MFN 06-249

**Subject: Response to Portion of NRC Request for Additional Information
Letter No. 26 Related to ESBWR Design Certification Application –
Isolation Condenser – RAI Numbers 5.4-21, 5.4-23 through 5.4-26,
5.4-28 through 5.4-30, 5.4-32 through 5.4-35, 5.4-38, 5.4-41, 5.4-42,
5.4-44 through 5.4-46, 5.4-48, 5.4-50, and 5.4-52**

**Response to Portion of NRC Request for
Additional Information Letter No. 26
Related to ESBWR Design Certification Application
Isolation Condenser**

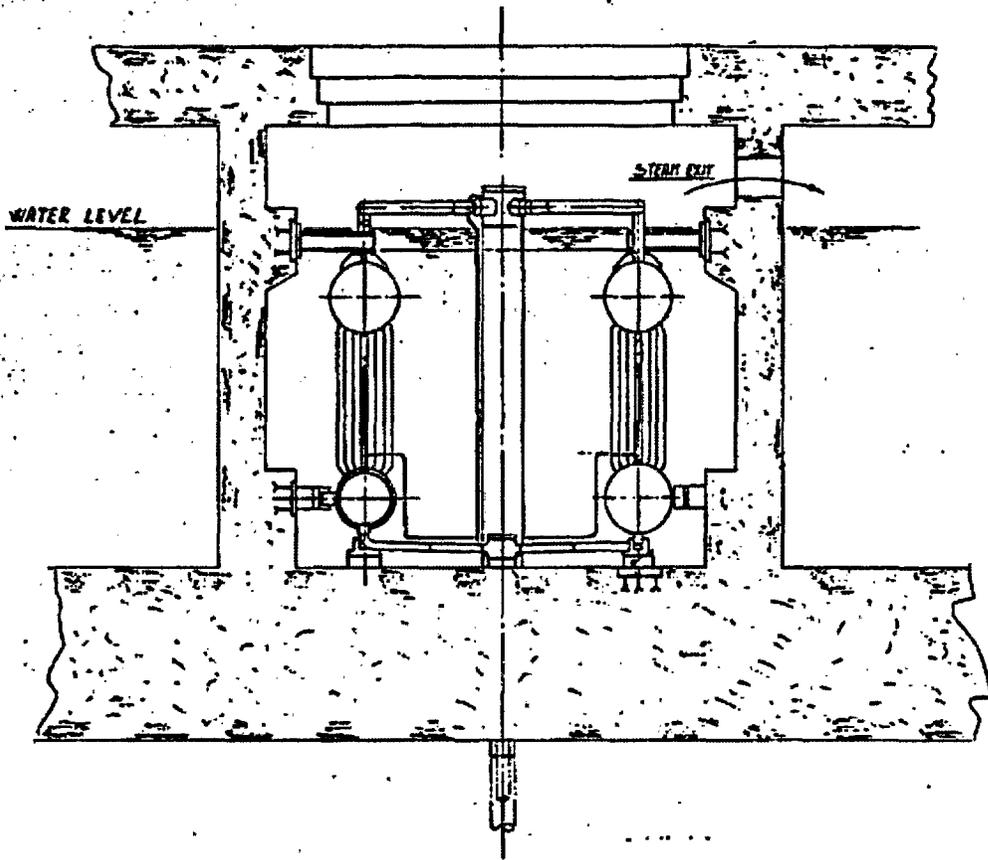
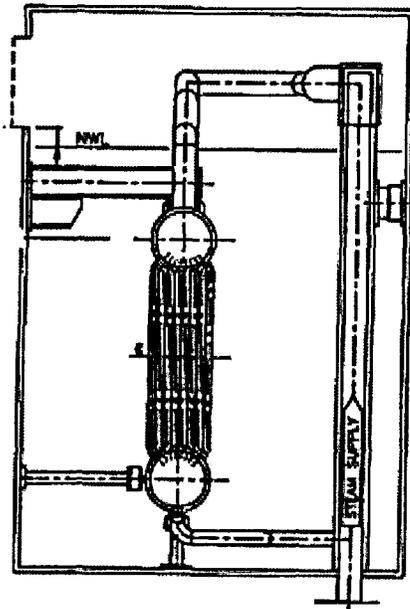
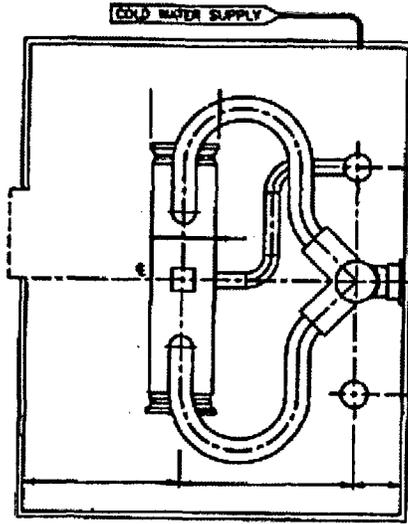
The isolation condenser (IC) for the ESBWR is a vertical heat exchanger significantly different from operating plants' ICs. Provide the following: a detailed description of the heat exchanger, the heat transfer coefficient required for this heat exchanger, and a drawing of the ESBWR IC in DCD Tier 2.

A schematic of the IC heat exchanger was provided to the NRC in the SEIT Panther ICS Test Report. In Appendix A of this letter is a copy of the schematic found in the Panther Test Report and an ANSALDO P&ID. A drawing of the IC will not be included in Tier 2 of the DCD.
